SUBJECT: Response to the Nuclear Regulatory Commission (NRC) Comments on the
Lowman, Idaho Draft Completion Report

Review of the Lowman, ID Draft Completion Report resulted in comments by the Nuclear Regulatory Commission (NRC), which require responses. The comments resulted in a modification to the Draft Completion Report, which have been addressed in the following text. Revisions to the initial attachments have been shaded for easy identification. The replacement pages are not shaded and are included behind the tab labeled "Replacement Pages" at the end of each attachment. Eight (8), three-holed copies of the replacement pages have been included for revision to the Draft Completion Report in the possession of DOE, NRC, and the State of Idaho.

SUBJECT: Response to the Department of Energy (DOE) Comments of Responses to the Nuclear Regulatory Commission (NRC) Comments on the Lowman, Idaho Draft Completion Report

FIGURE 02090-1

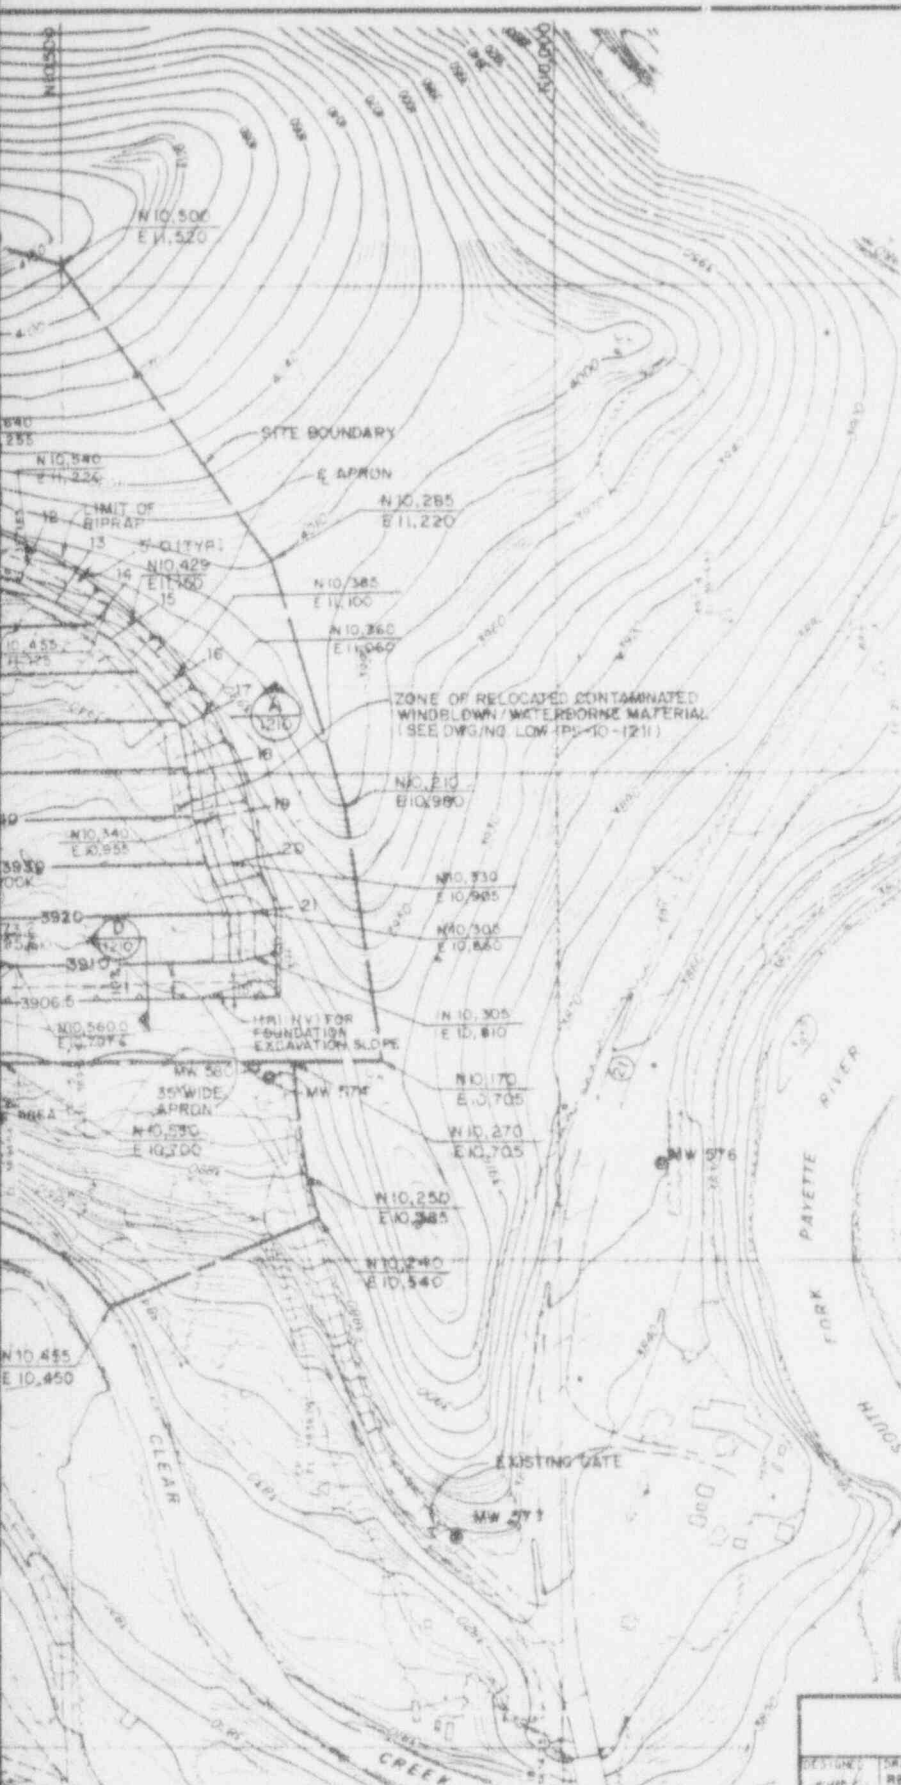
6. As-built drawings do not show the locations of abandoned piezometers situated beneath the designed disposal cell. DOE should update the as-built drawings to include the locations of abandoned wells and piezometers. DOE should also provide the abandonment procedures for the piezometers, if those procedures varied for the well abandonment specification in the RAP.

The locations of the wells and piezometers were not added to the As-Built drawings since they are considered to be no longer in existence. As-Built drawings are generated to show the condition of the existing features of the site after remediation. The location of the wells and piezometers were indicated in the RAP. The Monitor wells that were still in existence at the end of remedial action are shown on As-Built Drawing LOW-PS-10-1209. This As-Built Drawing has been revised to show Well No. 641. (See "Step-By-Step" below)

- Step No. 1: Obtain Volume 2, Appendix C, turn to "Section 2090 Well Abandonment".
 - Step No. 2: Obtain Attachment No. 4, and insert "Replacement Pages" after Page 2090 - 5, and before "Section 02110 Site Clearing" section.
 - Step No. 3: Turn to Appendix D, titled "As-Built Drawings" and remove As-Built Drawing No. LOW-PS-10-1209.
 - Step No. 4: Obtain Attachment No. 5, and insert "Replacement Pages" after As-Built Drawing No. LOW-PS-10-1208 and before As-Built Drawing No. LOW-PS-10-1210.
7. DOE should revise tabulations of the measured quantities of water actually used for dust control and tailings material compaction.
